February 9, 1993
LD-93-016

SUBJECT: Revisions to CESSAR-DC Chapter 15 Safety Analyses Results

REVISIONS TO CESSAR-DC CHAPTER 15

SYSTEM 80+ DESIGN AT 3914 MWt

SYS80+ : IOSGADV + LOOP
DNBR

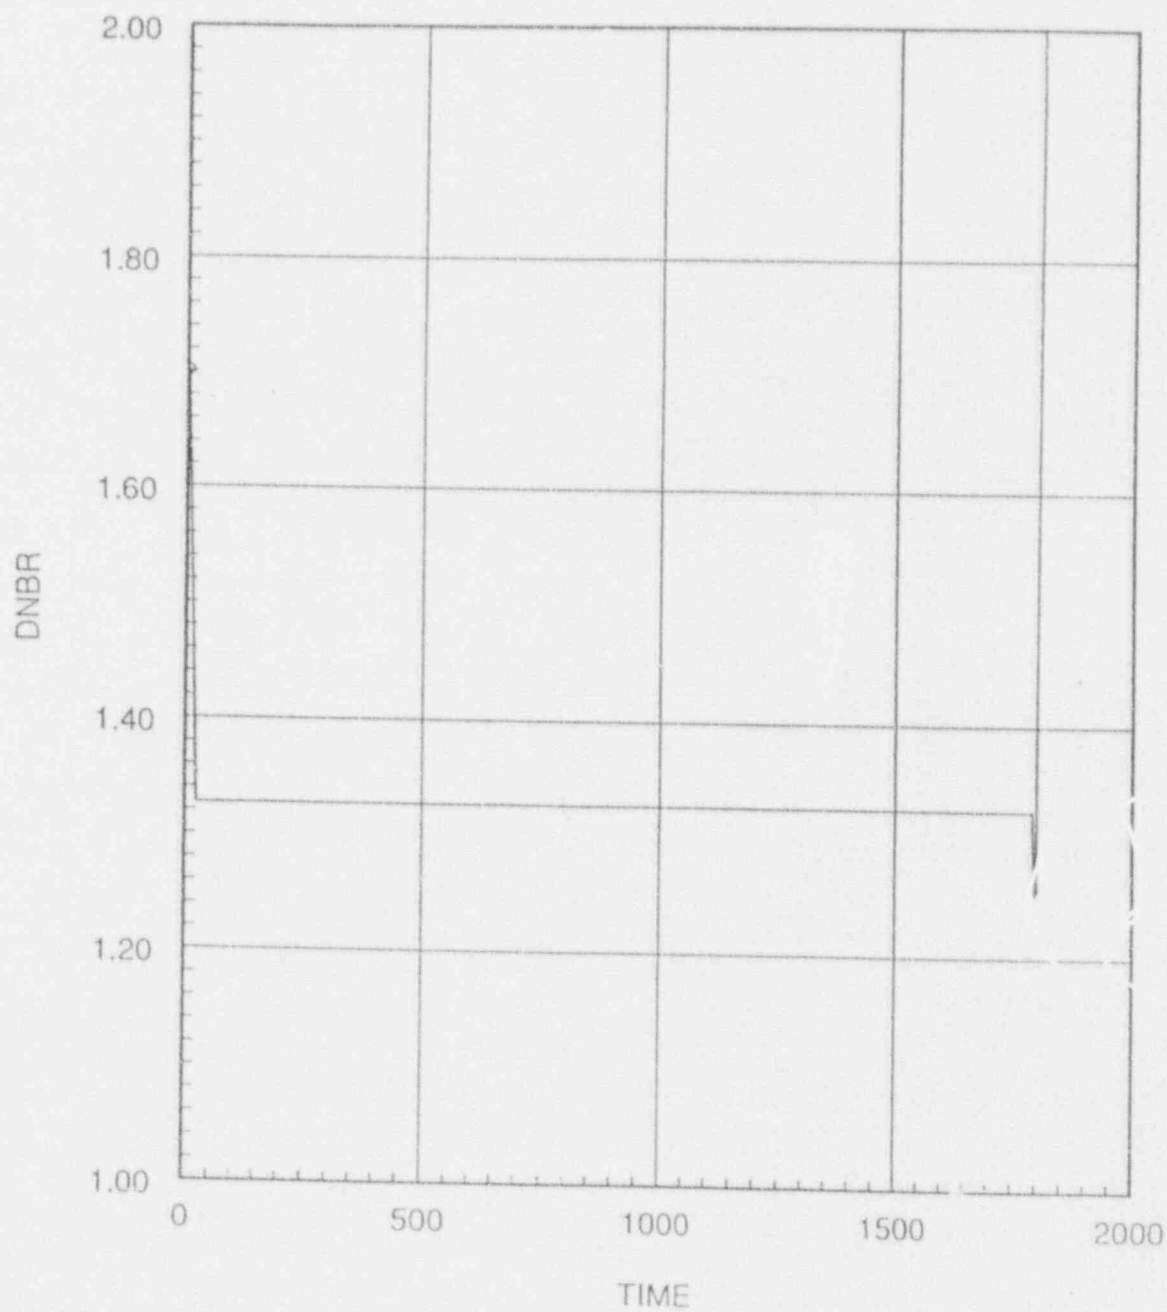
A re-analysis of the inadvertent opening of a steam generator relief or safety valve event has demonstrated that the conclusions presented in Section 15.1.4.4 of CESSAR-DC for this event remain unchanged for the System 80+ power upgrade. The inadvertent opening of a steam generator atmospheric dump valve with loss of offsite power concurrent with turbine trip results in a transient minimum DNBR greater than the SAFDL and consequently no fuel pins are in DNB. The attached figure presents the transient minimum DNBR for this event as calculated by the CETOP code. The changes in the results and initial conditions due to the System 80+ power upgrade are shown in the attached mark-ups of Tables 15.1.4-1 and 3 of CESSAR-DC.

SYS80+ : SLBFP post trip no LOOP
REACTIVITY

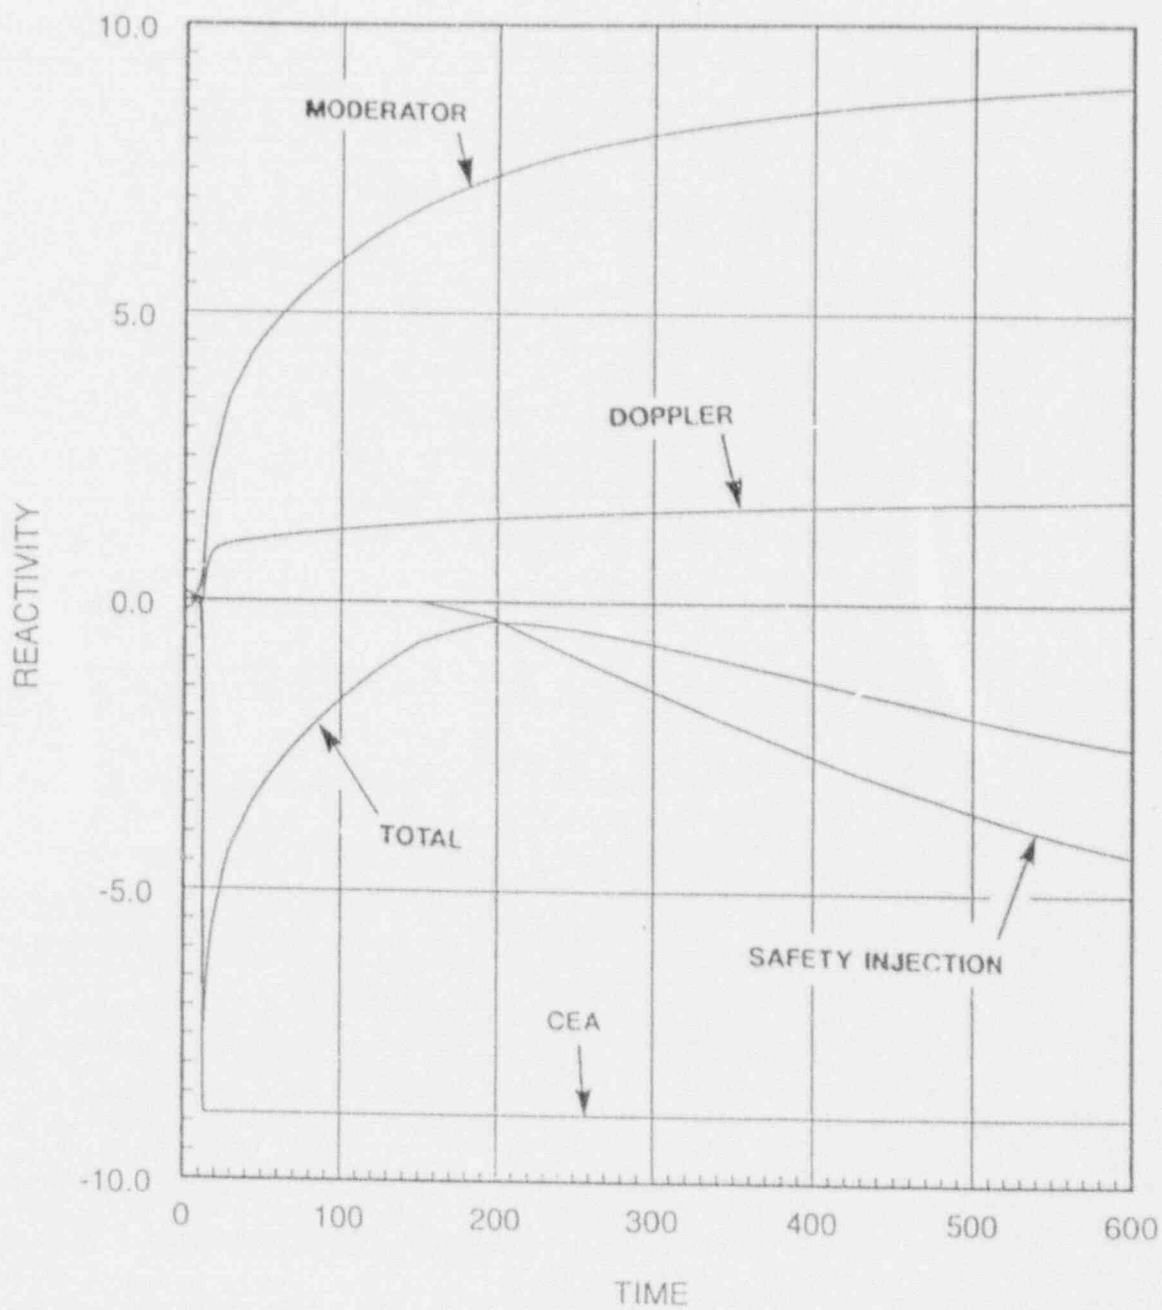
For case A. (SLBFP) the maximum post-trip core reactivity is -0.889 percent delta rho. There is no return to power, thus, the values of DNBR remain above those for which fuel damage would be indicated. The attached figure presents the transient reactivities for this event. The changes in the initial conditions and results due to the System 80+ power upgrade are shown in the attached mark-ups of Tables 12-1 and 2 (taken from the ABB-CENP response to Item 12 of NRC RAI 440.96).

SYS80+ : SLBFP pre trip with LOOP
DNBR

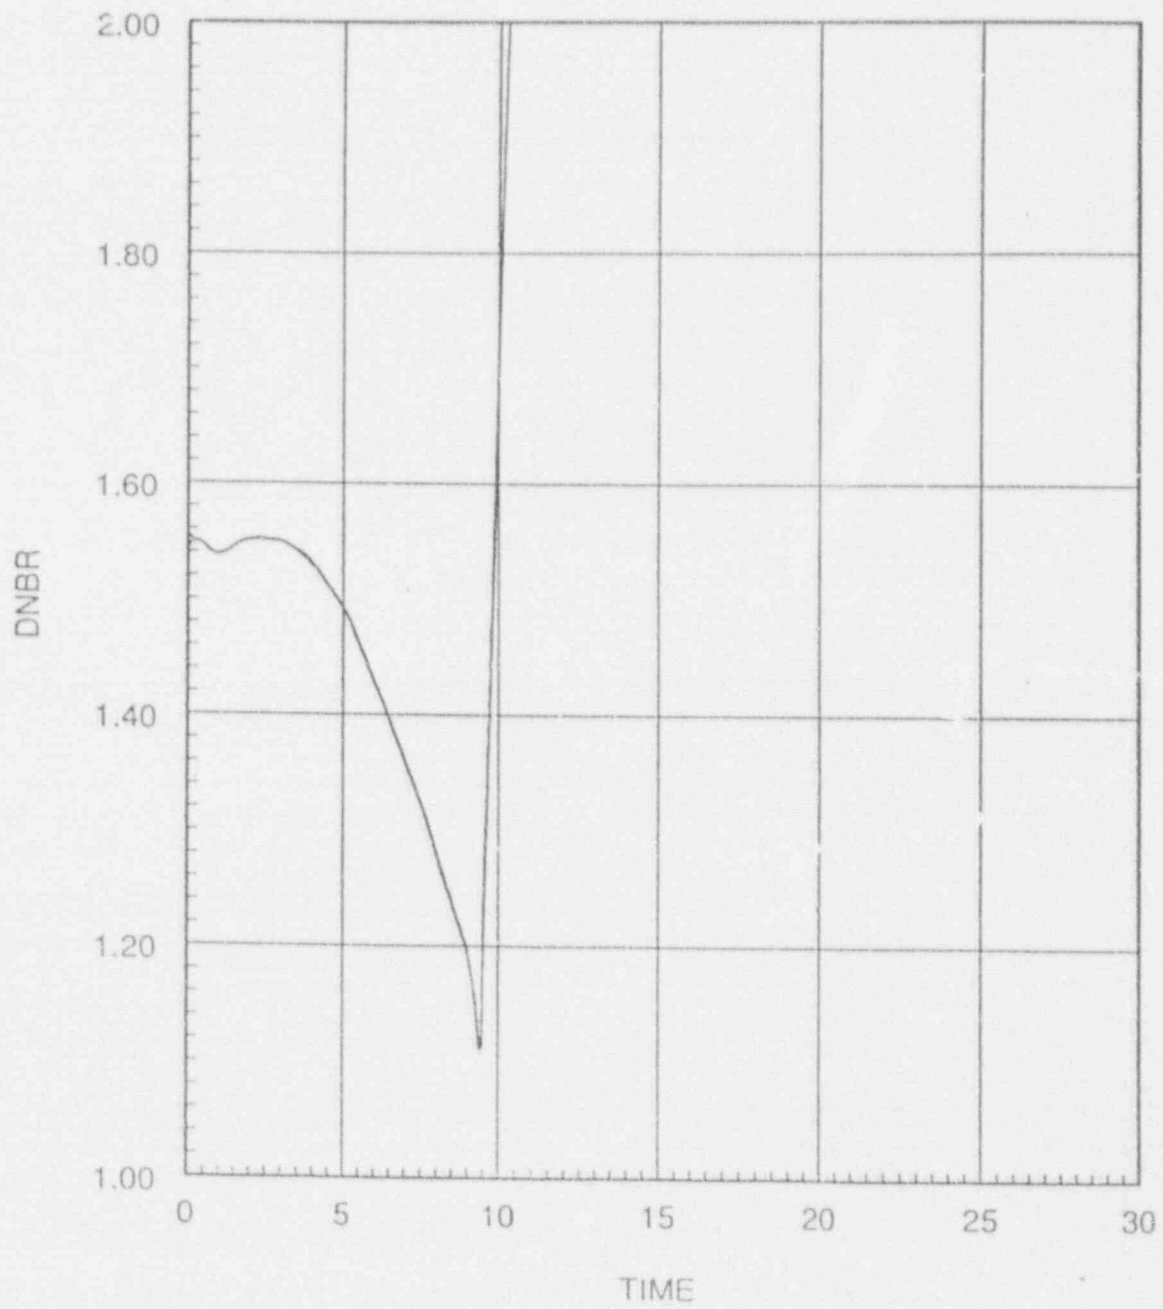
For case B. (SLBFPLOPD) the transient minimum DNBR is greater than 1.15. This results in less than 0.5% of the fuel rods being predicted to be in DNB. The consequent two-hour thyroid inhalation dose at the EAB was conservatively calculated using the TID-14844 source term to be less than 140 rem, which is within 10 CFR 100 guidelines. The doses will be even lower when NUREG-1465 sources are used. The attached figure presents the transient minimum DNBR for this event. The changes in the results and initial conditions due to the System 80+ power upgrade are shown in the attached mark-ups of Tables 15.1.5-5 and 10 of CESSAR-DC.

Figure 15.2.8.1

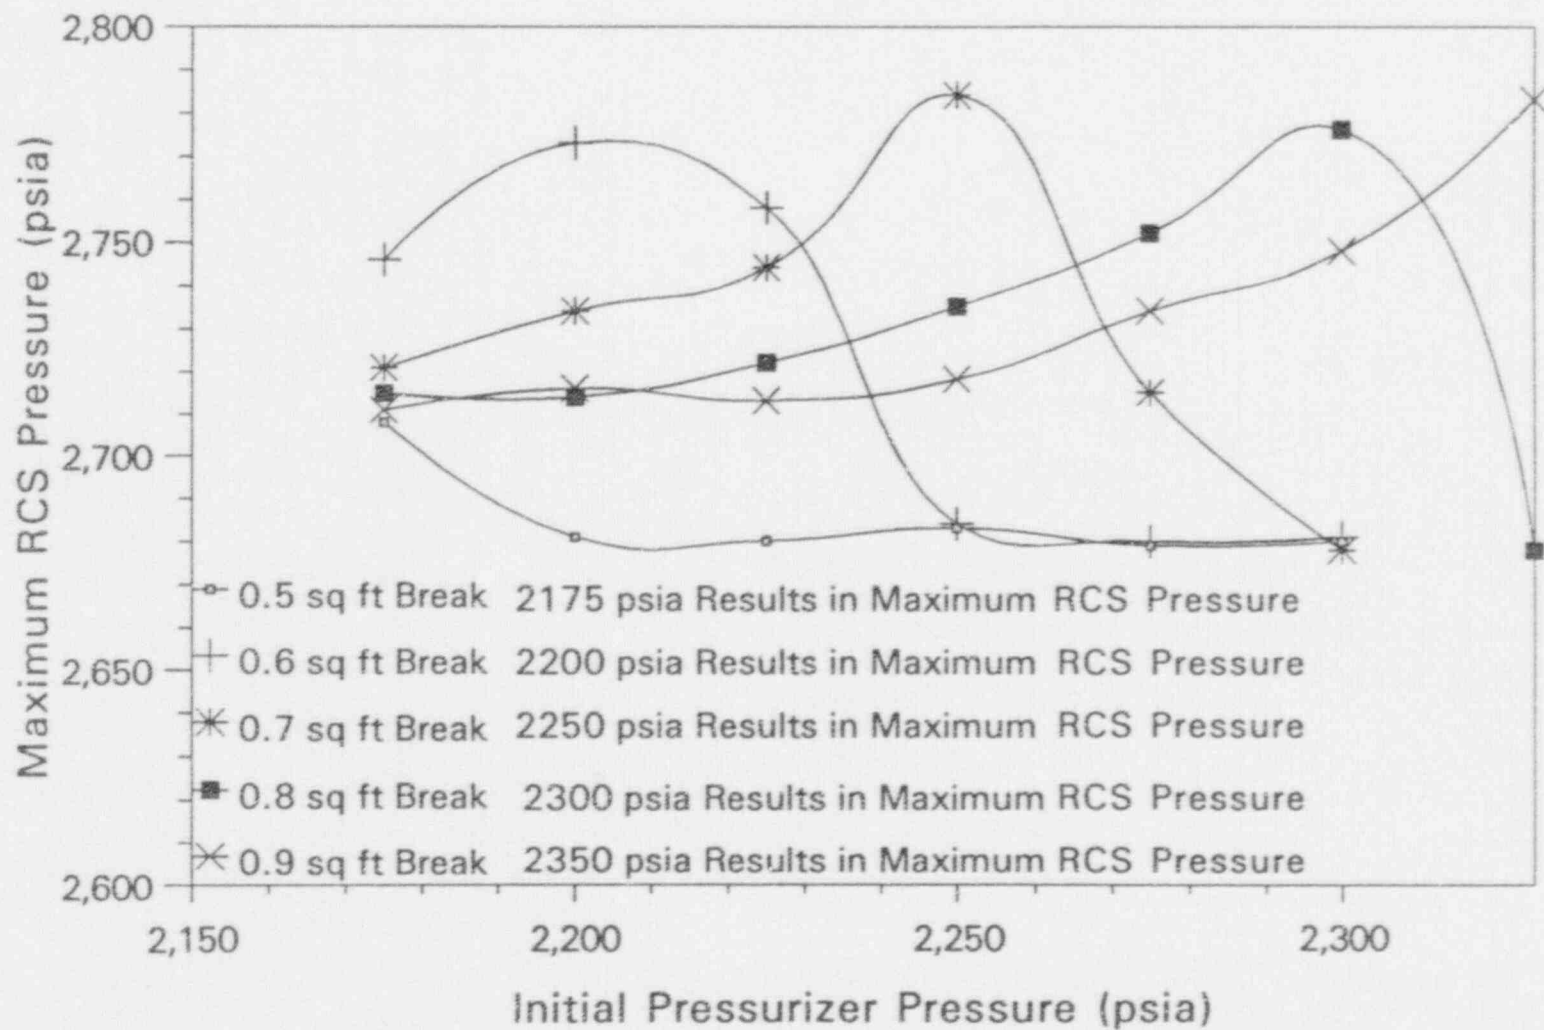
A parametric study covering break size and initial pressurizer pressure was performed. Figure 15.2.8-1 shows the maximum RCS pressure results for break sizes of 0.5 to 0.9 square feet as a function of initial operating pressurizer pressure. As can be seen for any given break size, there is a peak pressure for some initial pressurizer pressure. This is the initial pressure at which the affected steam generator dry out coincides with the pressurizer high pressure trip. If the initial pressurizer pressure is lower than that where the maximum transient peak pressure occurs the affected steam generator will dry out prior to the pressurizer high pressure trip, resulting in a lower pressure at the time of reactor trip. Similarly, if the initial pressure is higher than that where the maximum peak pressure occurs, the pressurizer high pressure setpoint is reached prior to affected steam generator dry out. This results in a lower peak pressure during the accident due to residual water inventory in

the ruptured steam generator providing greater heat removal after the trip, thus limiting the peak pressure. For all break sizes, when the initial pressurizer pressure is far from the initial pressure which results in the maximum transient peak pressure for that break size the peak pressure is approximately 2680 psia.

Figure 15.2.8.2

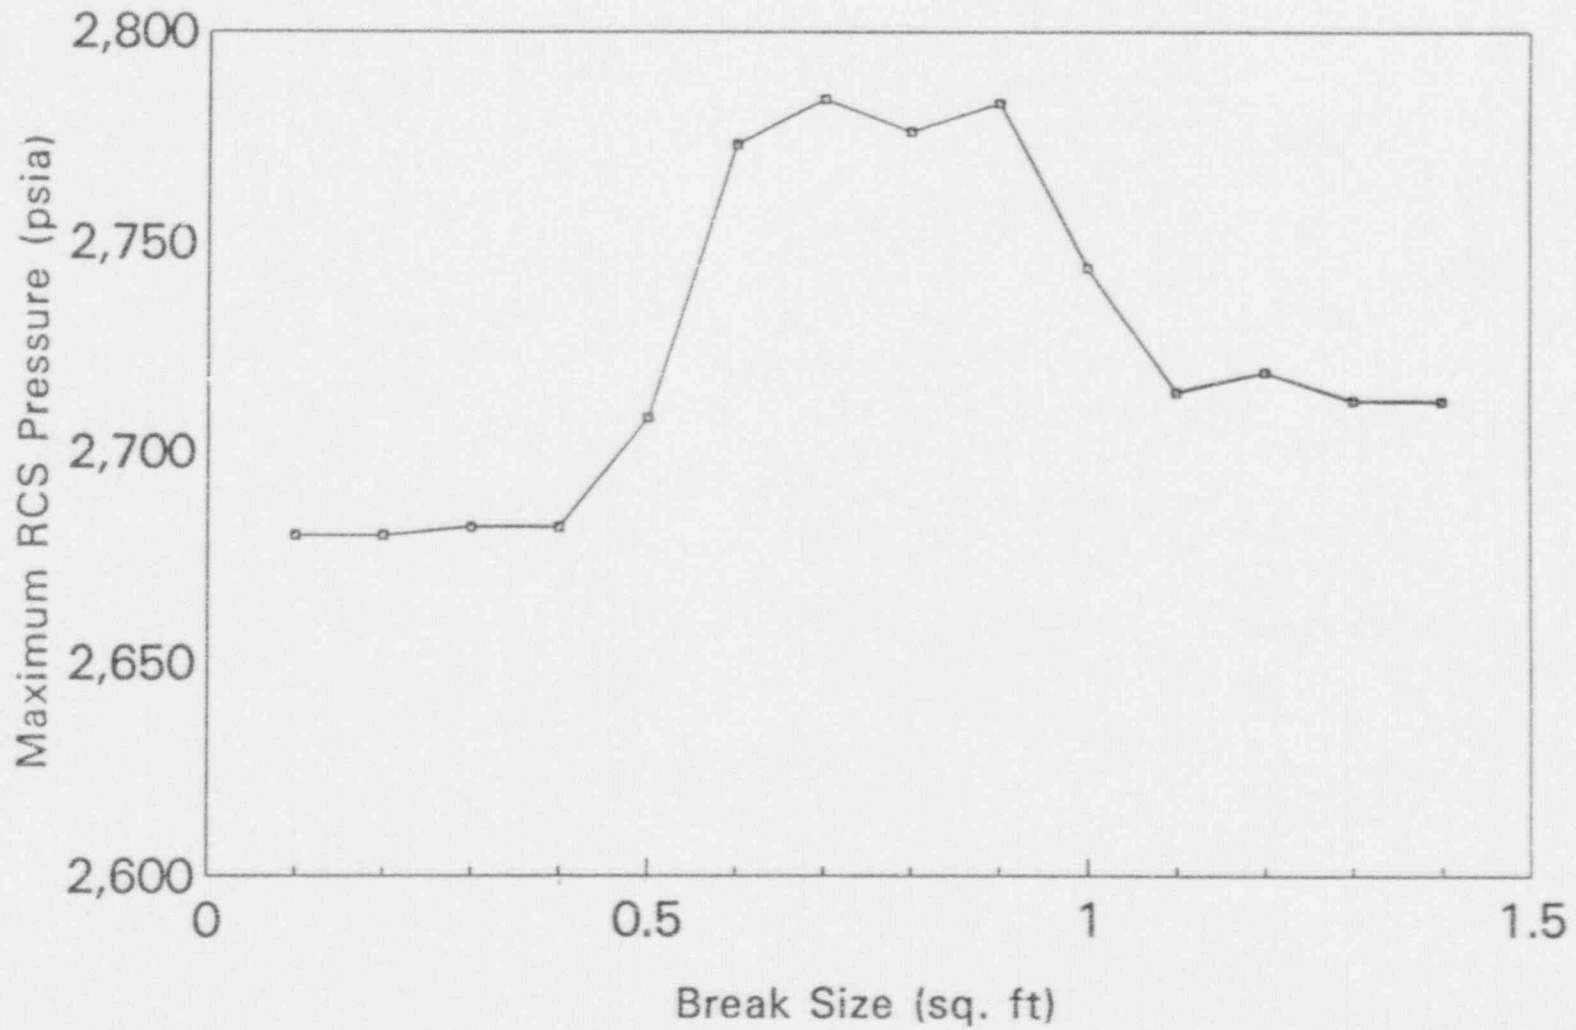
The maximum peak pressure achieved as a function of break size is shown in Figure 15.2.8-2. As can be seen for break sizes below 0.5 square feet, the peak pressure is well below 110% of the design as required for those breaks. The highest pressure reached is still within 120% of design pressure for large breaks.

FIG.15.3.3-11 SYSTEM 80+ SEIZED ROTOR LOOP 102%POWER
Minimum DNBR vs. Time

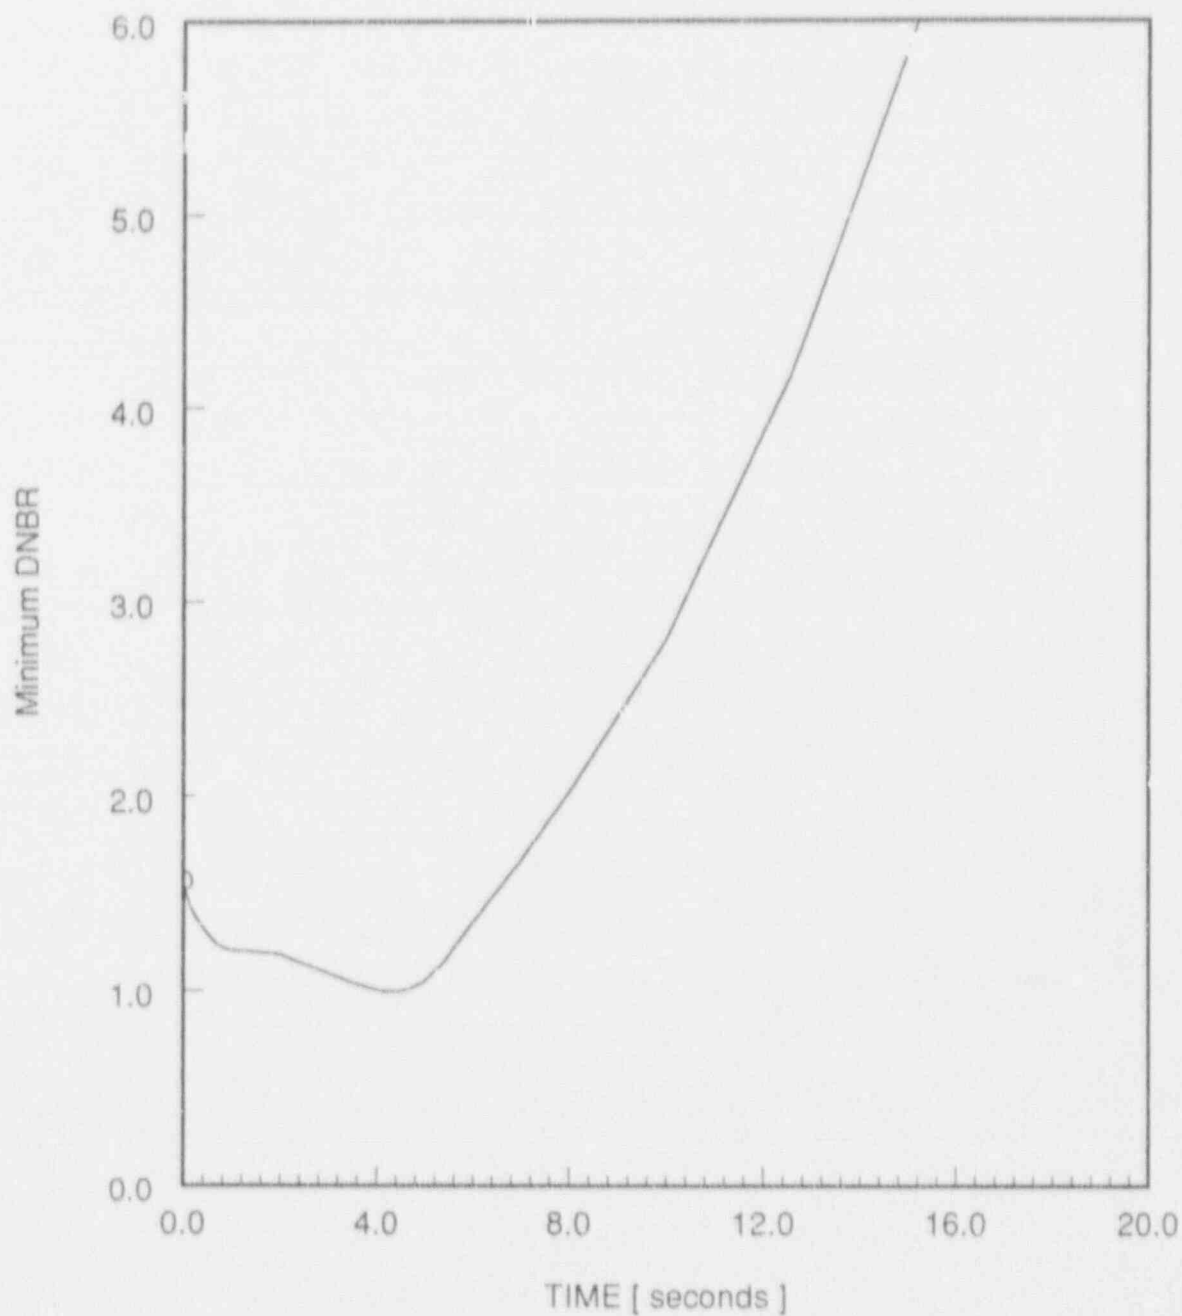
The minimum DNBR/fuel failure aspect of the analysis has been performed to demonstrate that the resultant offsite doses remain within 10CFR100 guidelines. The enclosed Figure 15.3.3-11 presents the minimum DNBR versus time for the most limiting initial conditions. It has been conservatively determined (based on the convolution method, Reference 1) that no more than 2.5 percent of the fuel should fail due to the RCP rotor seizure event with loss of offsite power coincident with the turbine trip. A brief summary of the results are presented below.
